**RE: 60 CASTLE CIRCUIT, SEAFORTH -REQUEST FOR FURTHER INFORMATION**

**DA2023/0696**

In response to Council's correspondence, dated 11 September 2023, amended plans include:

**Figure 1: Height as submitted as viewed from the north.**

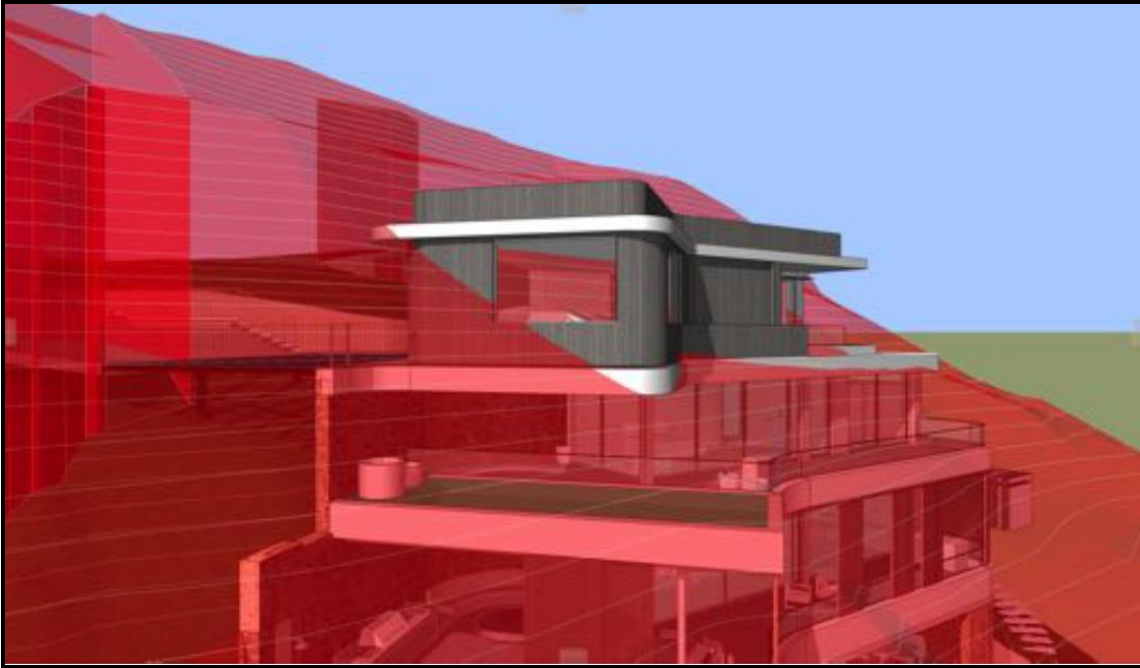
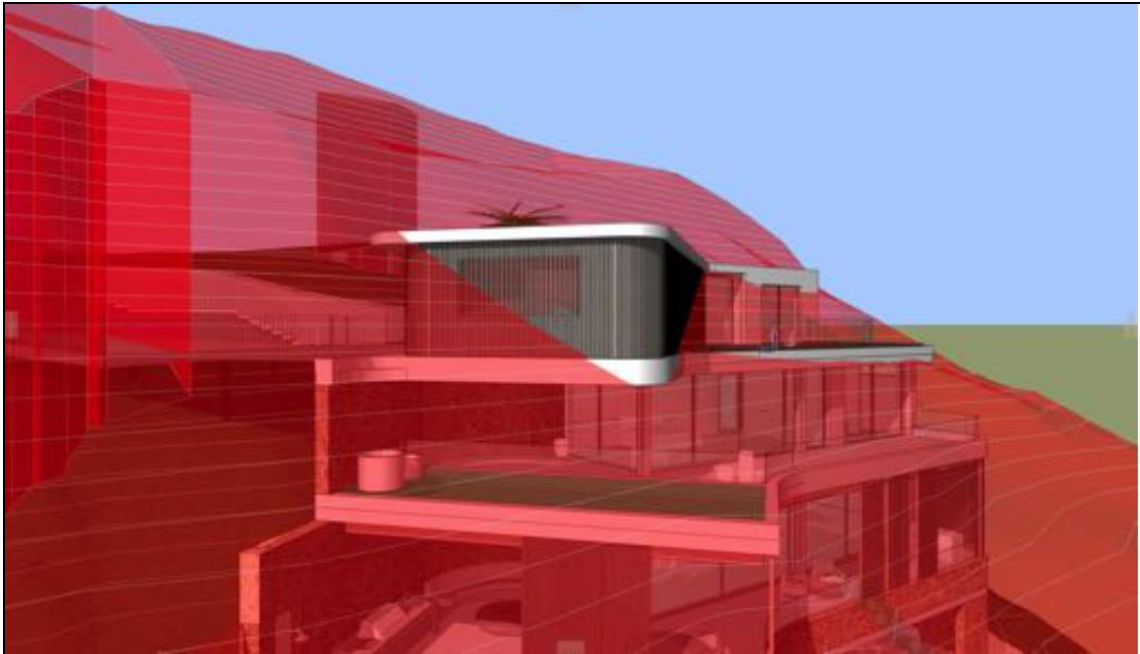
The proposed height has been reduced from that submitted with the DA, as shown in the comparison between that submitted and amended. It is apparent that the built form and height has been reduced in accordance with Council's comments in the correspondence. The following 3D images confirm that the height variations are confined to components of the uppermost level.

1. Reduction in excavation behind the house on Level 1, Level 2 and Level 3. This deletes the subterranean drainage cavity spaces as shown on the plans attached. It also reduces the size of the Plant Room & Storage zone under the Level 2 Terrace.

2. Level 4 changes to reduce height, bulk, floor area and visual impact when viewed from West and South-West:
  - a) Powder Room deleted.
  - b) Study relocated.

- c) Laundry, Plant and Bin Storage relocated.
  - d) Southern end of Garage reduced.
  - e) Roof Garden now dominates Western elevation (in response to foreshore view concern)

3. Roof Level changes:
  - a) Parapet deleted.
  - b) Roof height reduced by 450mm from RL47.17 to RL46.72(4500mm reduction)
  - c) Shape amended to suit Level 4 changes.

- d) Roof/eave projection to west of Study deleted.
4. Reduction in FSR from 0.44:1 (329.9sqm) to 0.43:1 (323.33sqm) and reduction in overall bulk through an increased setback from the western frontage

**Figure 3: 3D aerial view which shows that the built form will be screened from the north and north-west from Castle Circuit by the established bushland which extends north of the subject site.**

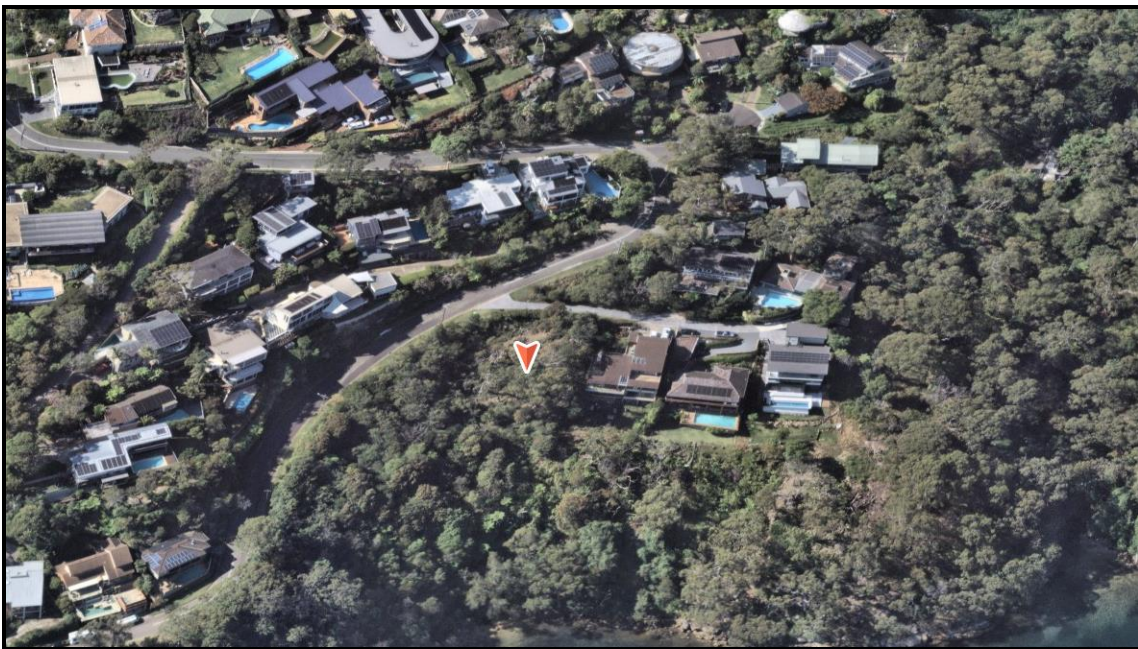
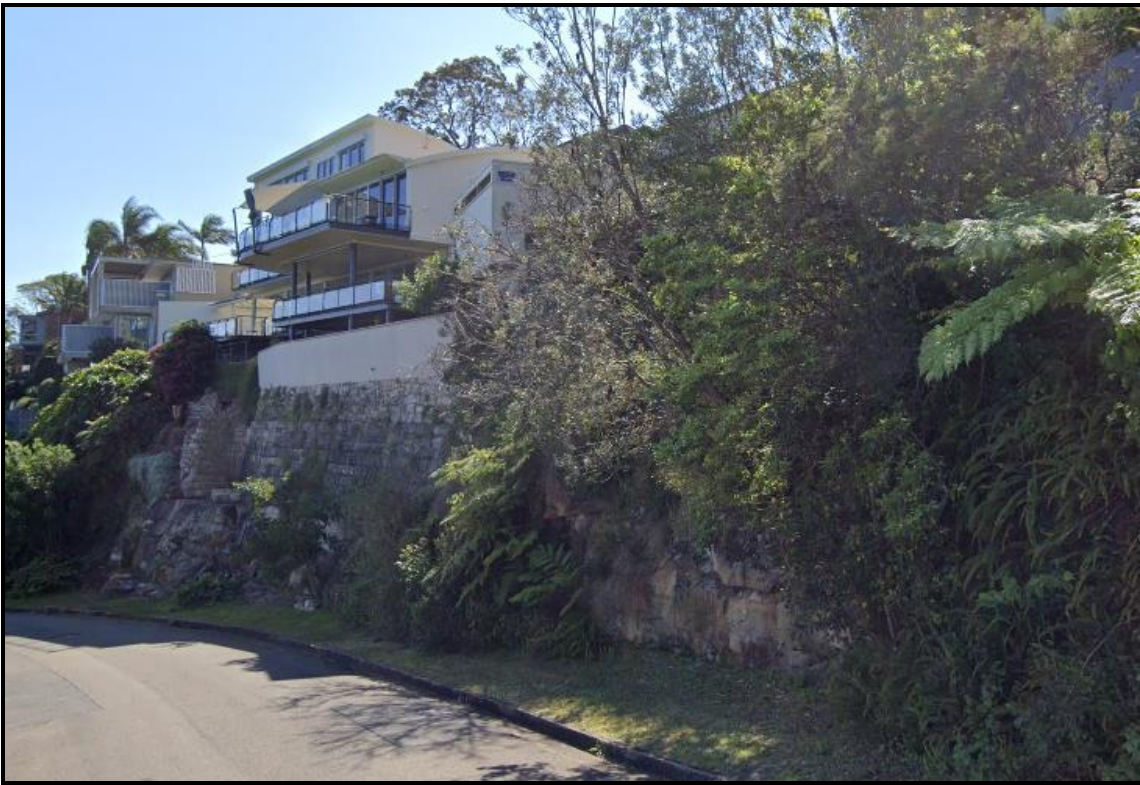
The above images are taken from an elevated location and do not represent the view of the building that would be available having regard to the sloping nature of Castle Circuit to the south of the site as well as the dense bushland to the south of the site. It is thereby considered that the above height variation would not be evident from any public vantage point along Castle Circuit. It is acknowledged that the overall height will be visible from the harbour to the west of the site, however, the proposed built form will be perceived against the backdrop of the sloping topography which includes substantially larger and more prominent dwellings higher upslope. The subject site represents the northernmost site in this section of Castle Circuit whilst the land to the west and north-west is zoned C2 which prohibits dwelling houses. This confirms that the bushland to the north, north-west and west of the site is likely to remain and maintain an effective landscape buffer. On this basis, the proposed height will not generate any visual bulk concerns from either public vantage points (i.e. Castle Circuit or the harbour).

**Figure 8: View of existing and proposed views of the streetscape and site in general which shows that the single storey garage/entry form will not generate any adverse streetscape impacts whilst the proposed replacement plantings will actually improve views to the harbour from the public domain**

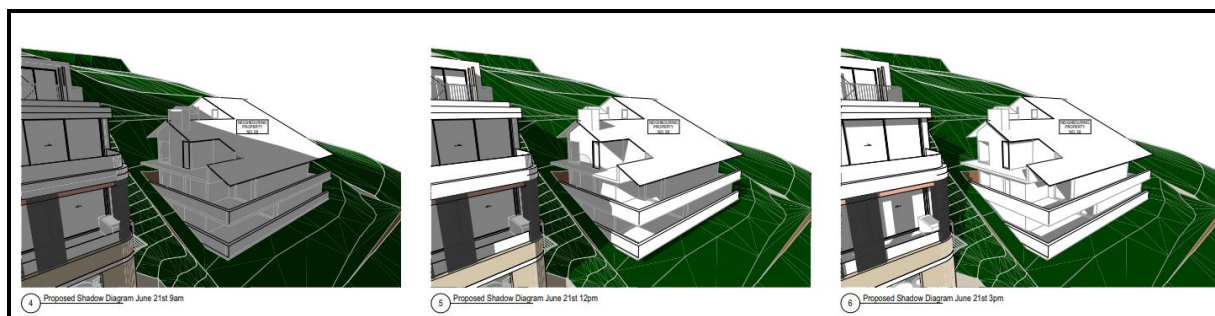
It is reiterated that the proposed height variation will be imperceptible from Castle Circuit due to the steep slope of the site downwards from the site frontage towards the harbour. On this basis, it is confirmed that the height variation will not be responsible for any adverse streetscape impacts, as shown below:

**Figure 9: View from higher up slope showing the single storey of the built form.**

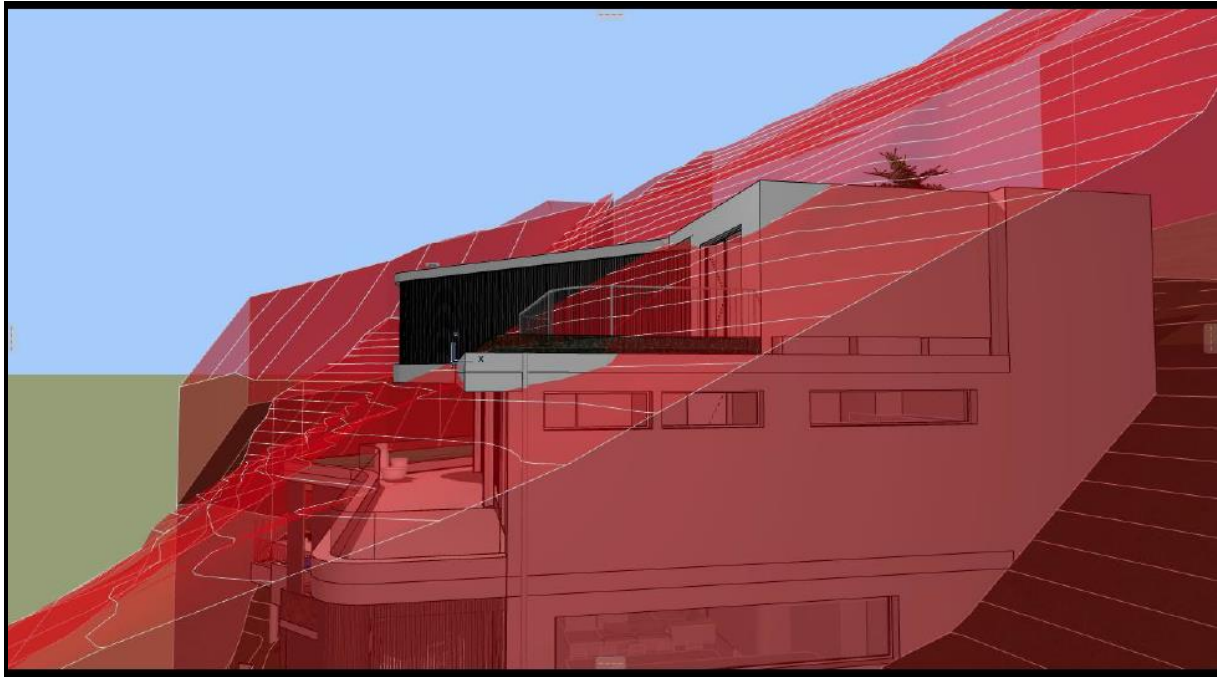
Furthermore, the height variation will not be apparent from the properties higher upslope as shown in the image below:

**Figure 12: Excerpt of sections A and B which show that the excess FSR could be attributed to the lowest level which is below existing ground level**

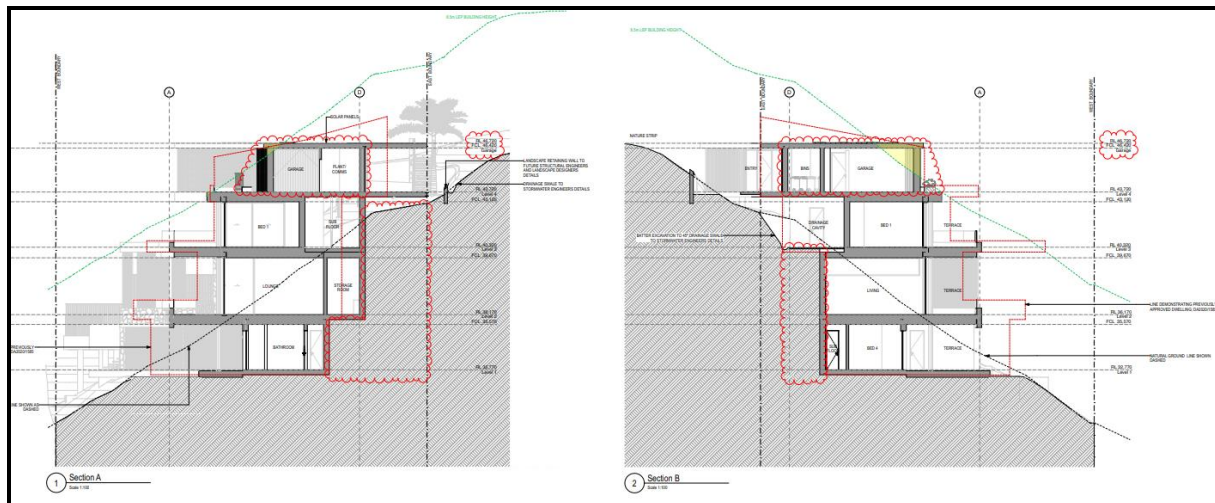
If the additional GFA is located elsewhere, it could be within Level 1 (the lowest level). GFA in this level is concealed from the public domain, from the sole adjoining neighbour to the south and from the harbour. The GFA is also below existing ground level as confirmed on the series of section diagrams, as shown below. On this basis, the above-ground level FSR would be compliant.

The above sections also show that the approved dwelling extended beyond the proposed building envelope. Whilst slightly numerically greater than the approved dwelling, it is reiterated that the subject dwelling includes additional articulation and architectural quality.

Figure 13: Excerpt of Section Diagrams

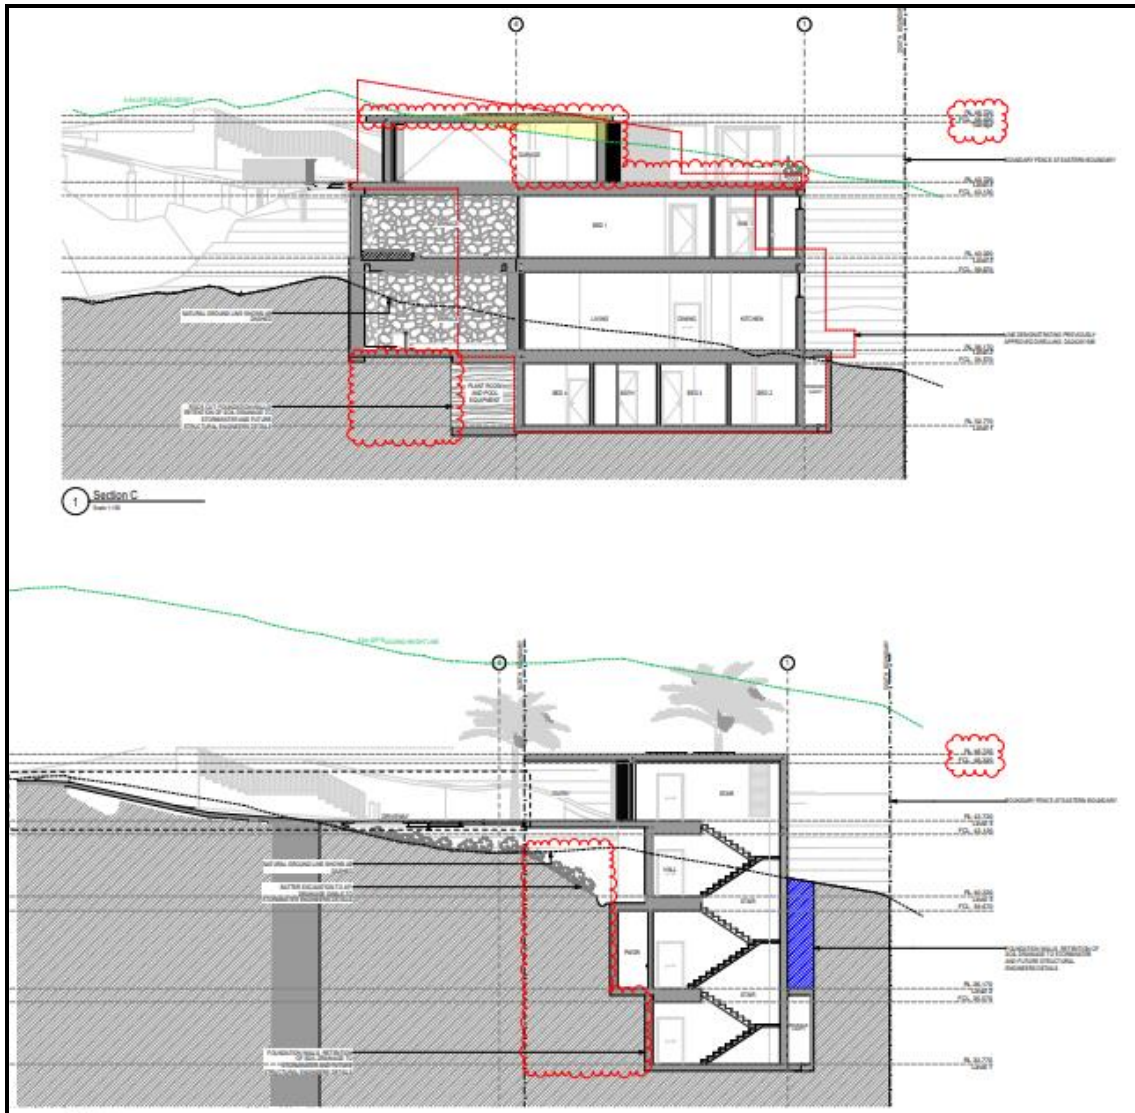
The amended proposal has significantly reduced the extent of excavation as confirmed in the above section diagrams. The reduced level of excavation is shown in Sections A & B above as well as in Sections C & D below. The reduced level of excavation is considered to address the concerns raised in the correspondence.
